MPCA Review - Taconite Mercury Reduction Plans 2020 Statewide Mercury TMDL Oversight Committee Meeting

Hassan Bouchareb | Engineer

February 5, 2021

Initial MPCA review

U.S. Steel - Keetac

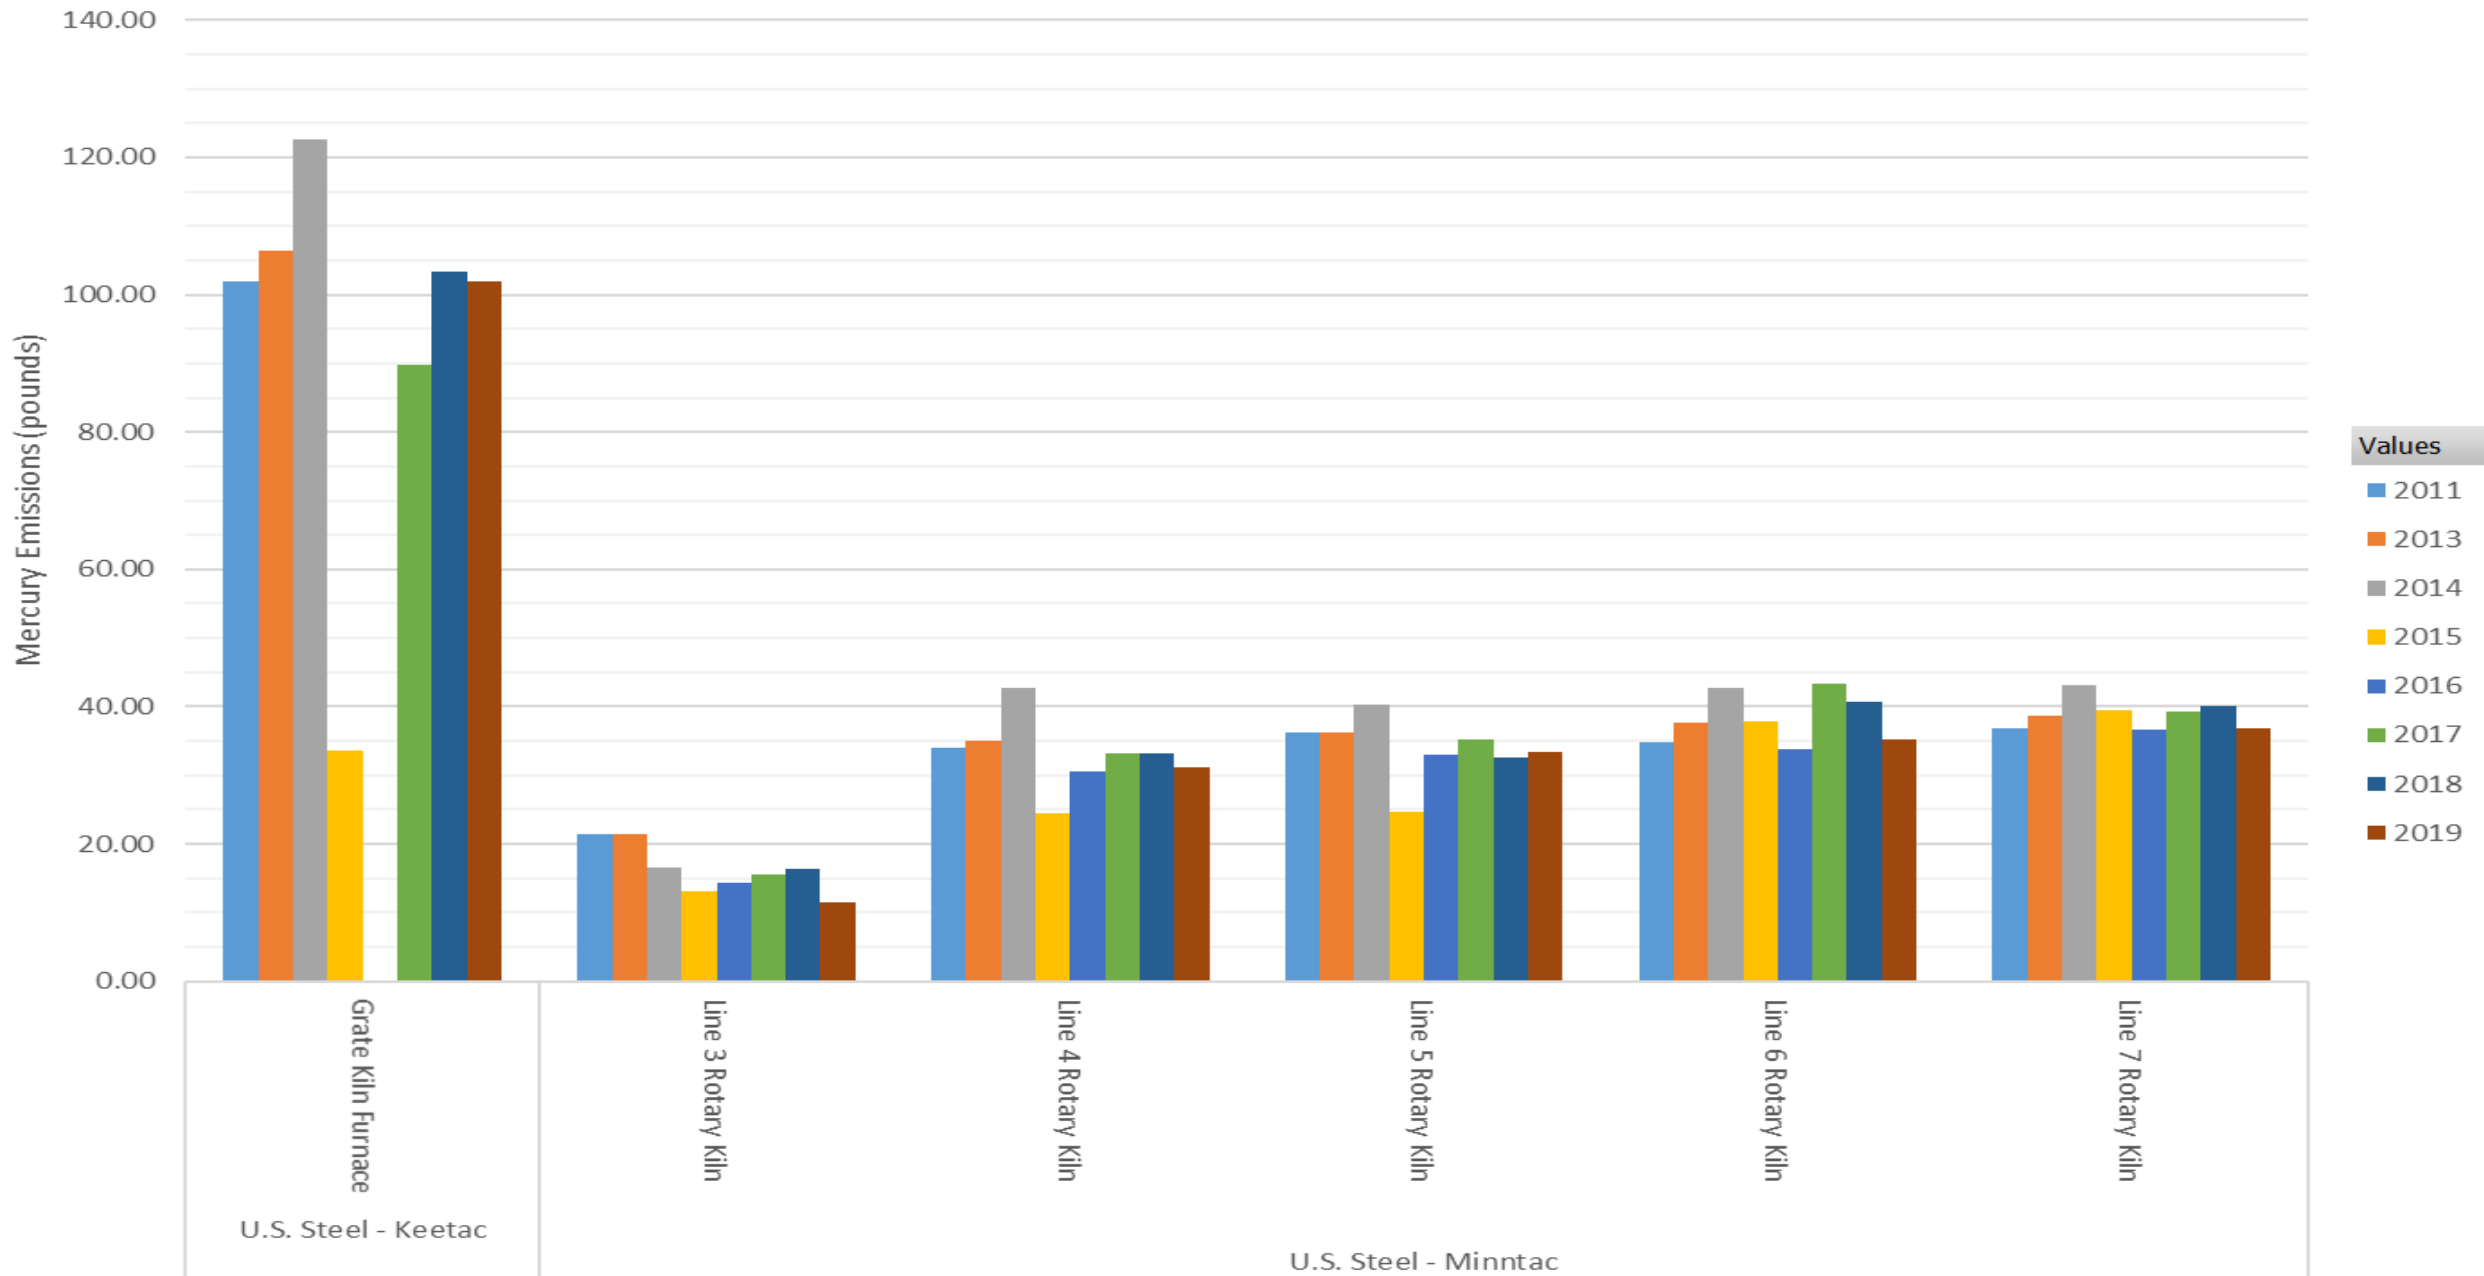
- Proposal: No additional controls proposed
 - Previously achieved a ~30% reduction via existing scrubbers and solids wasting (~2005)
- MPCA Review
 - Baseline emissions (Indurating Furnace) = 96.16 lb
 - Mercury emissions rate = 26.92 lb (72% reduction)
 - Reoccurring evaluations to make progress towards the 72% reduction
 - Additional data on the capabilities of the existing wet scrubber
 - Additional stack tests for halide injection
 - Evaluations to explore improved particulate capture to address problems for activated carbon injection
 - Greenball sampling for additional methods of verifying mercury content

Minorca Mine

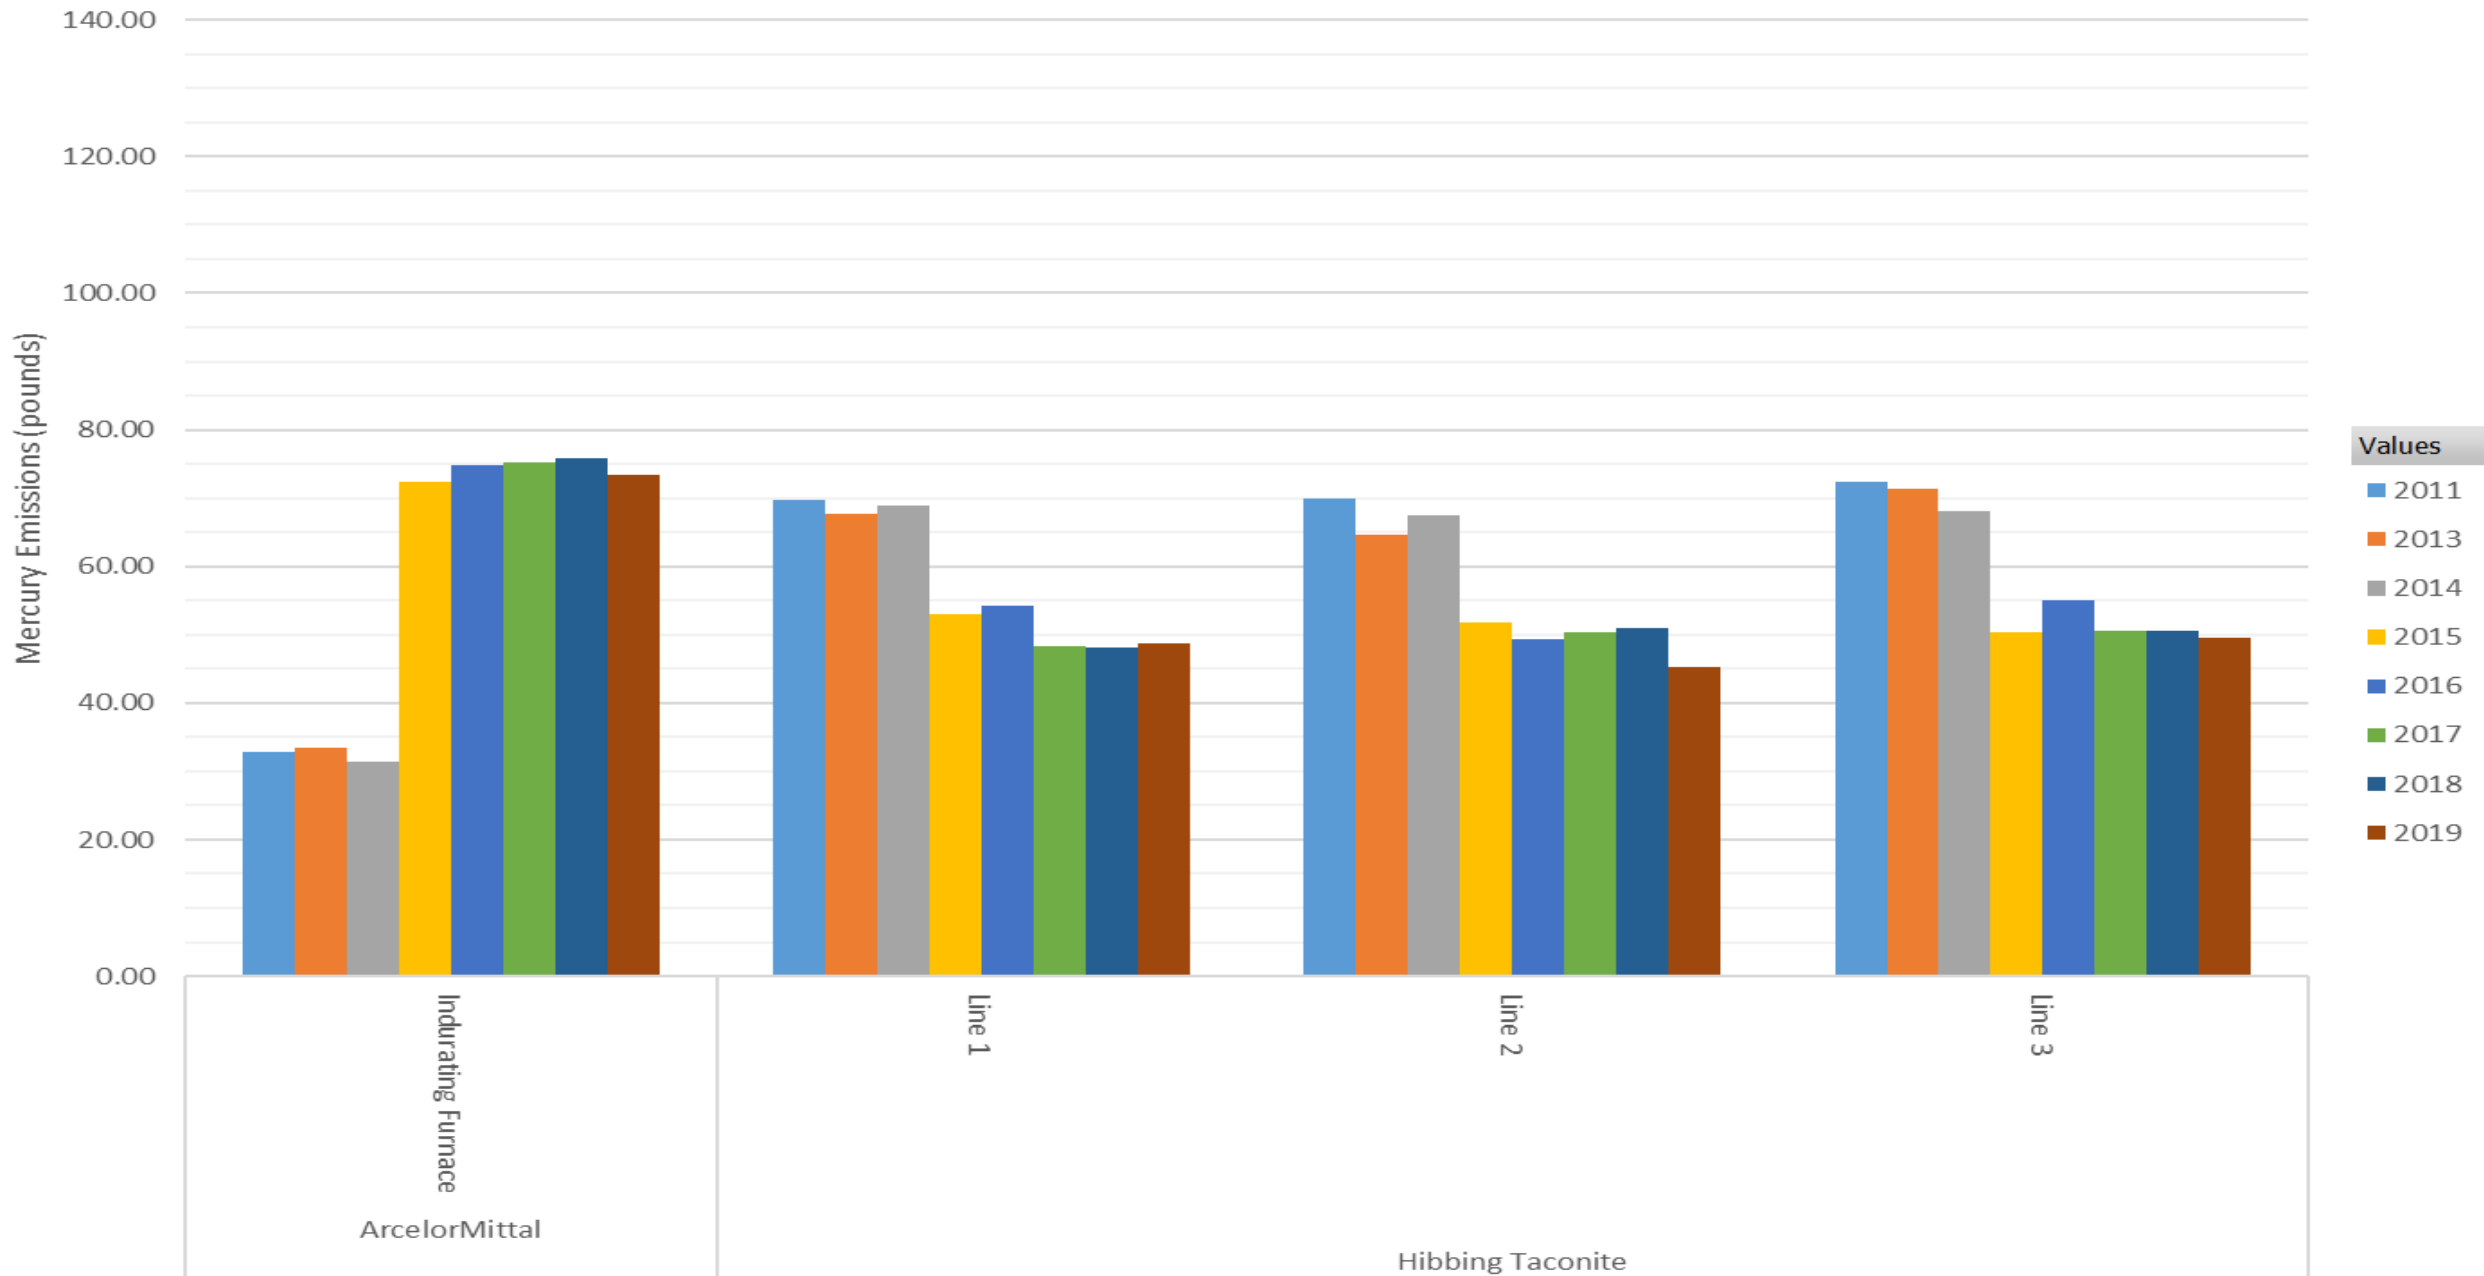
- Proposal: Scrubber solids wasting with existing wet scrubbers (22% reduction)
- MPCA review
 - Baseline emissions (Indurating Furnace) = 66.93 lb
 - Mercury emissions rate = 52.21 lb (22% reduction) vs. 18.74 lb (72% reduction)
 - Reoccurring evaluations to make progress towards the 72% reduction
 - Additional stack tests for scrubber solids wasting and halide injection
 - Evaluations to explore improved particulate capture to address problems for activated carbon injection
 - Greenball sampling for additional methods of verifying mercury content
